# Comhairle Chontae Atha Cliath Theas

## Record of Executive Business and Chief Executive's Order

**Reg. Reference:** SD22A/0155      **Application Date:** 30-May-2022  
**Submission Type:** New Application      **Registration Date:** 30-May-2022  
**Correspondence Name and Address:** CDP Architecture 4, Main Street, St. Edmondsbury,  
Lucan, Co. Dublin  
**Proposed Development:** Construction of a 2 two bed semi-detached dormer  
bungalows with access from Newlands Park for  
vehicular parking; all associated site works, car  
parking, landscaping and boundary treatments.  
**Location:** 13 Newlands Drive, Clondalkin, Dublin 22  
**Applicant Name:** H.H.M Investments Ltd  
**Application Type:** Permission

Permission is being sought for the construction of 2 no. two bed semi-detached dormer bungalows with access from Newlands Park for vehicular parking; all associated site works, car parking, landscaping and boundary treatments.

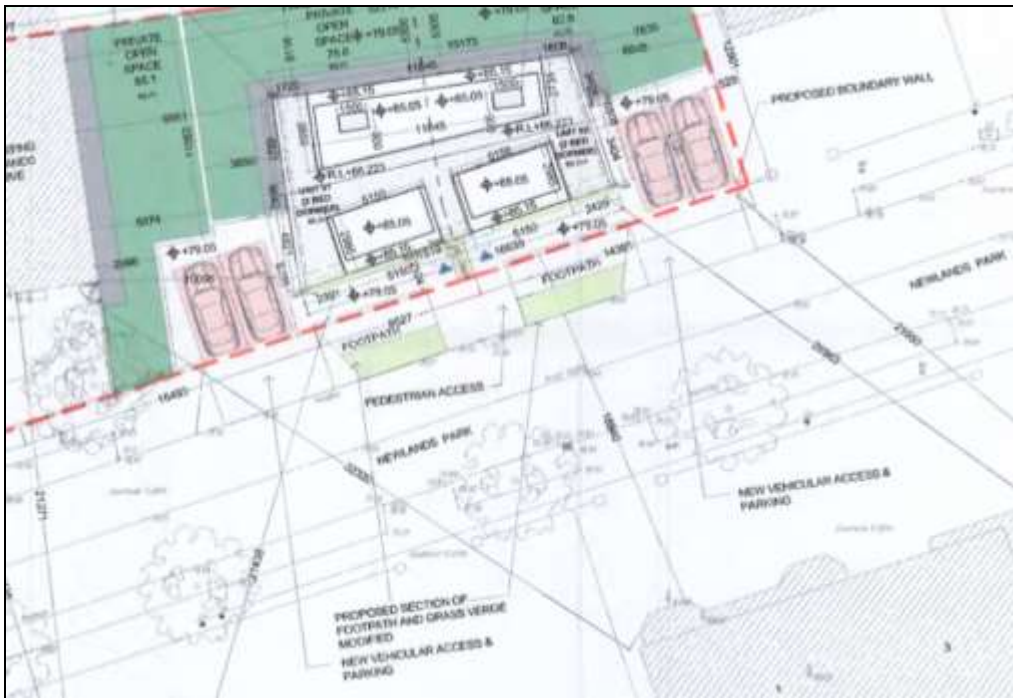
*The proposed front boundary wall is 1m high. SDCC Roads Department sets a height limit of 0.9m for boundary walls at vehicular access points in order to improve forward visibility for egressing vehicles.*

*Drivers of vehicles egressing the property should have adequate visibility before crossing the pedestrian footpath. The 1800mm high boundary walls at either end of the proposed properties may obstruct this visibility. The applicant has submitted a visibility splay, but it has been taken from 2.4m from the road edge. In order to ensure the safety of pedestrians, a visibility splay should be provided from a point 2m set back from the footpath edge.*

1. *The applicant is requested to submit accurate plans demonstrating the provision of a visibility splay of 2m x 23m in both directions from the entrance. Sightlines should be taken from the centre of the parking spaces closest to the boundary walls and from a point 2m setback from the footpath edge.*
2. *The applicant is to submit details of discussions with Public Realm in resolving tree conflict with access point.*
